NUCLEAR REGULATORY COMMISSION

Application of SOUTHERN CALIFORNIA	)	Docket No. 50-361
EDISON COMPANY, <u>ET AL.</u> for a Class 103	)	
License to Acquire, Possess, and Use	)	
a Utilization Facility as Part of	)	Amendment Application
Unit No. 2 of the San Onofre Nuclear	)	No. 110
Generating Station	)

This amendment application consists of Proposed Technical Specification Change No. NPF-10-357 to Facility Operating License No. NPF-10. Proposed Technical Specification Change No. NPF-10-357 is a request to delete references to the Movable In-Core Detector System (MICDS) in Technical Specifications 3.3.3.2, "In-Core Detectors, Limiting Condition for Operation," and 3/4.8.4, "Electrical Equipment Protection Devices" (Table 3.8-1, "Containment Penetration Conductor Overcurrent Protective Devices").

DESCRIPTION AND SAFETY ANALYSIS  
PROPOSED CHANGE NPF-10/15-357

Figure 1

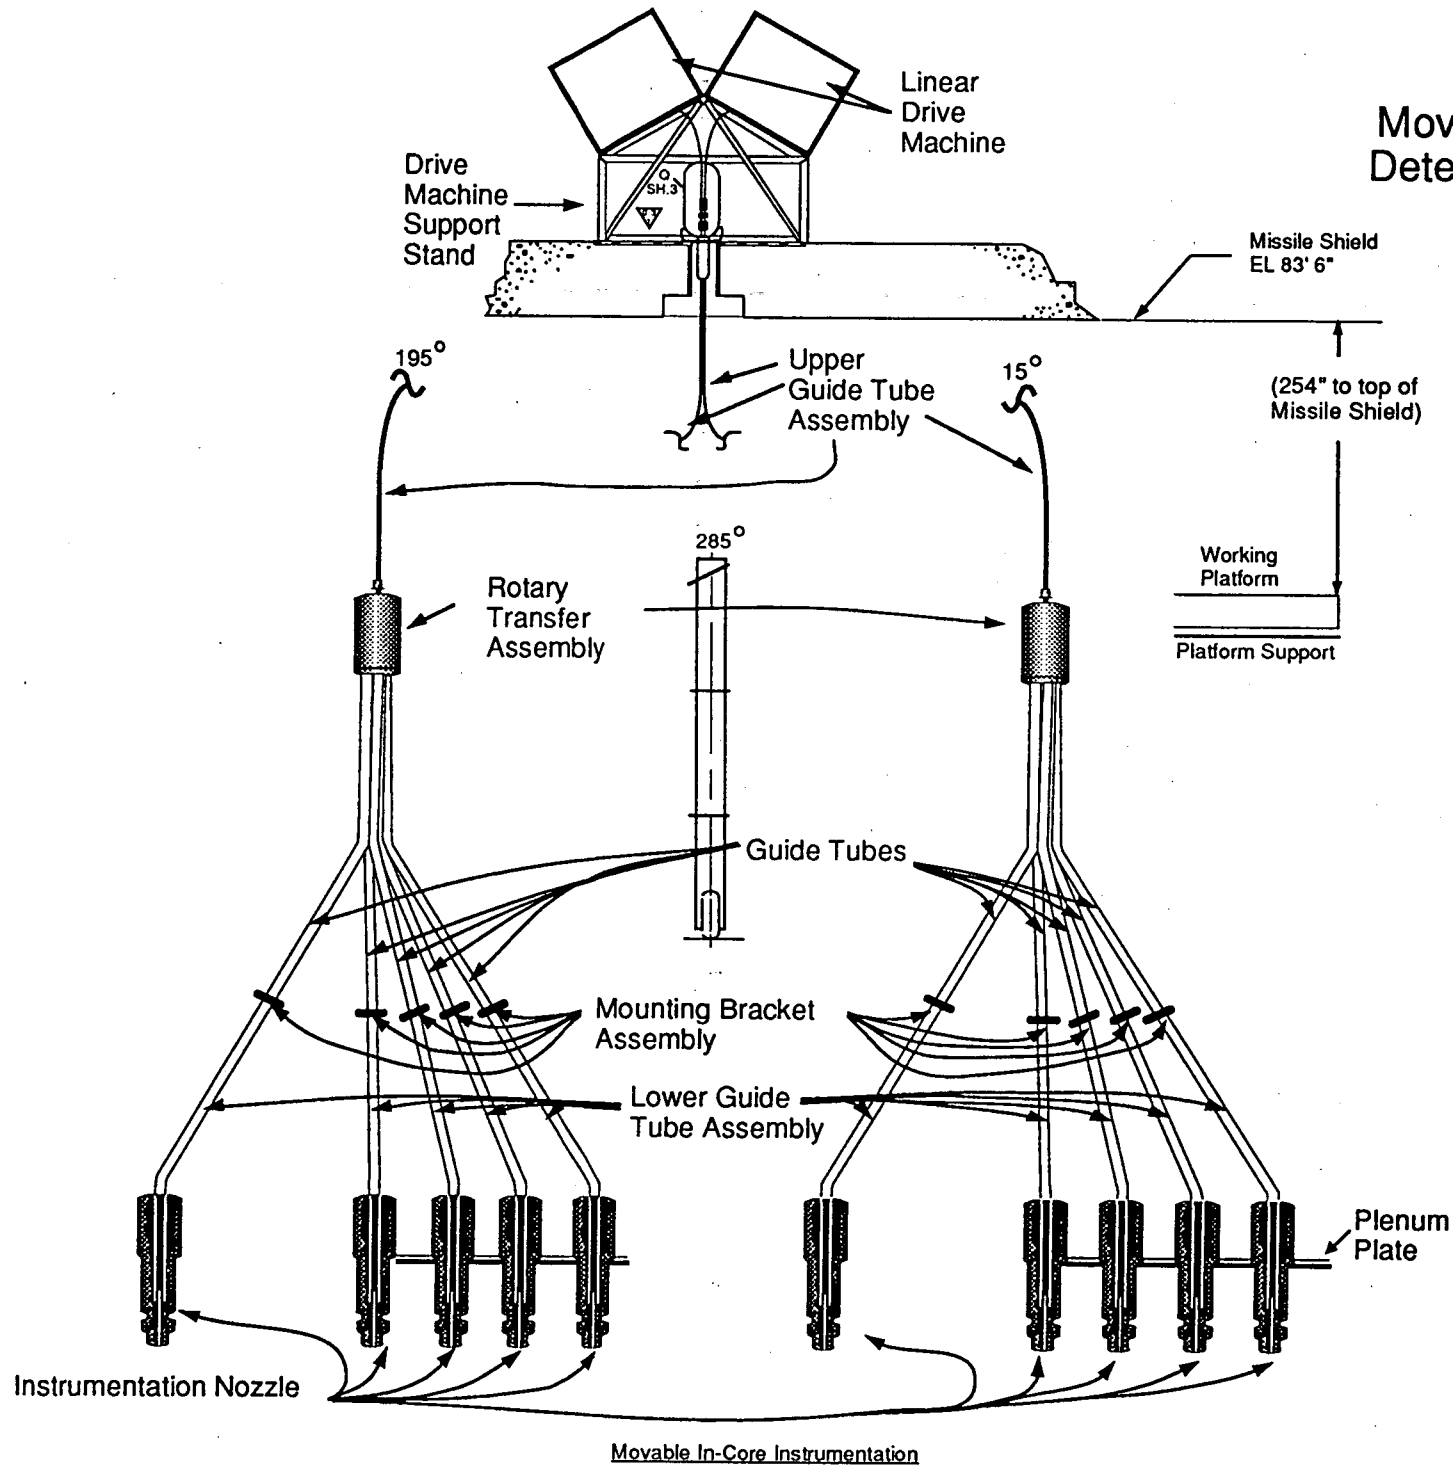
As reflected in the attached Figure 1, MICDS pathways consist of 2 upper guide tube assemblies that extend from the drive machines to the rotary transfer assemblies; 56 guide tubes that extend from the rotary transfer assemblies to the lower guide tube assemblies; and 56 lower guide tube assemblies that extend from the guide tubes to the ICI calibration tubes. As reflected in the attached Figure 2, the ICI calibration tubes and the fixed in-core detectors are components of the in-core detector assembly. Each calibration tube mates to the end of a lower guide tube assembly with a quick-disconnect fitting.

Similar failures have occurred at both San Onofre Unit 2 and Unit 3, which necessitated initiation of two TFMs that implemented 1) the removal of some of the associated tubing and 2) the installation of a pressure cap and an RTV plug on each ICI calibration tube.

- 1) The TFM for Unit 2 has removed both the guide tubes and the lower guide tube assemblies. The TFM for Unit 3 has removed only the lower guide tube assemblies. The remaining Unit 3 guide tubes will be removed during the next Unit 3 refueling outage.
- 2) The TFMs installed a vendor supplied pressure cap and a high temperature RTV plug on each of the ICI calibration tubes. The installation of the pressure caps eliminated potential RCS coolant leakage paths by capping the ICI calibration tubes. The vendor supplied pressure caps are designed to seal the calibration tube against system pressure if the pressure boundary of the fixed in-core detector is internally breached. The pressure caps are normally placed on each calibration tube during shipping and then removed when the fixed in-core detector is installed. The TFMs re-installed the pressure cap onto each ICI calibration tube.

Figure 2  
In-Core Detector Assembly

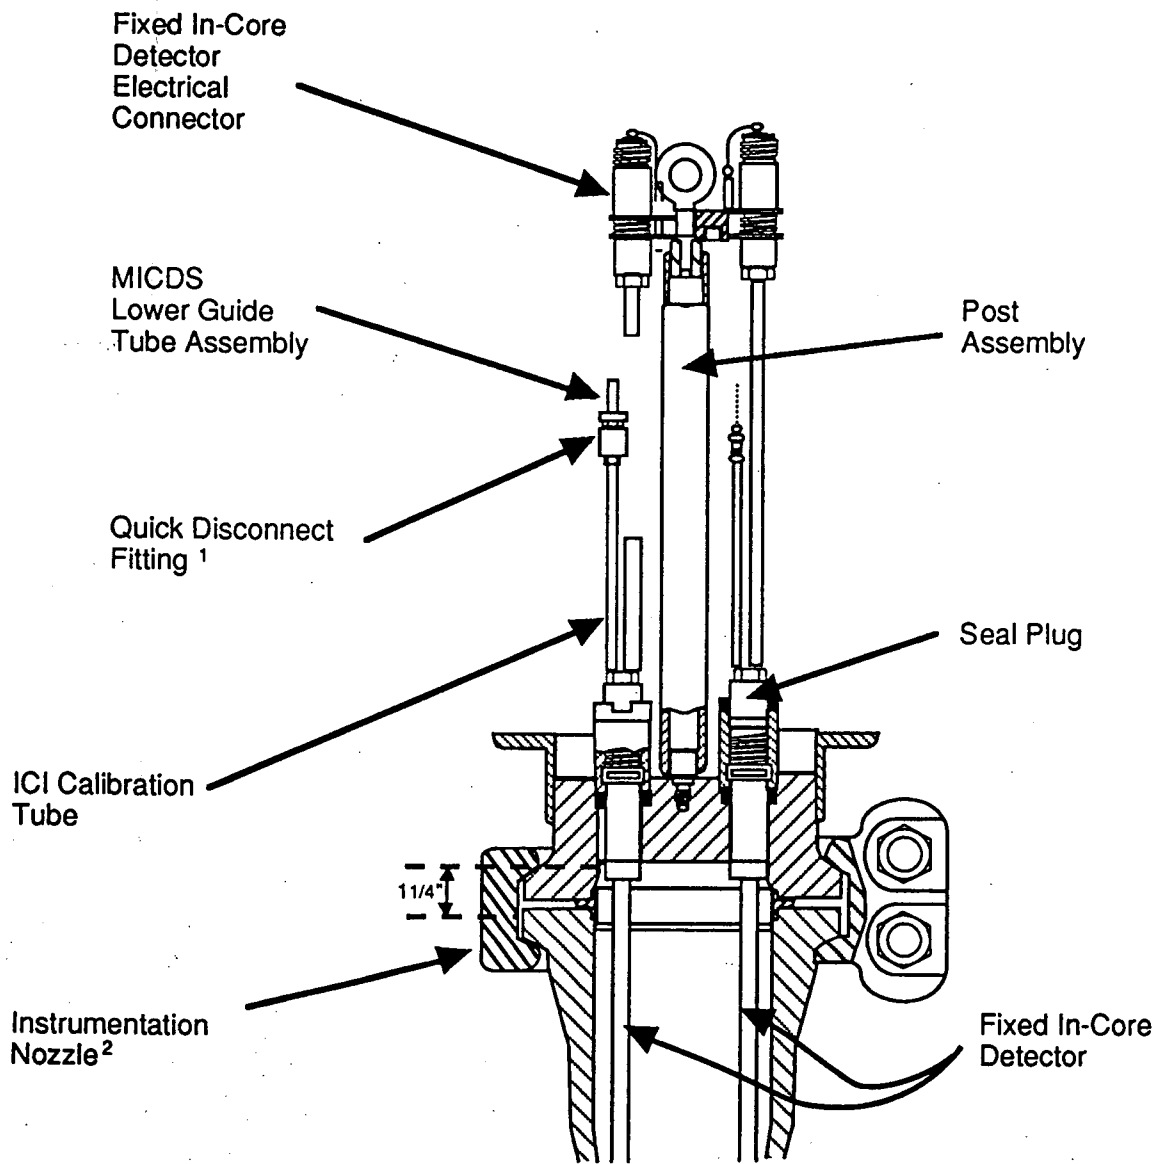
<sup>1</sup> The Quick Disconnect Fitting has been replaced with a pressure cap and an RTV plug.

<sup>2</sup> Each Instrumentation Nozzle is capable of allowing the penetration of a maximum of six In-Core detectors.
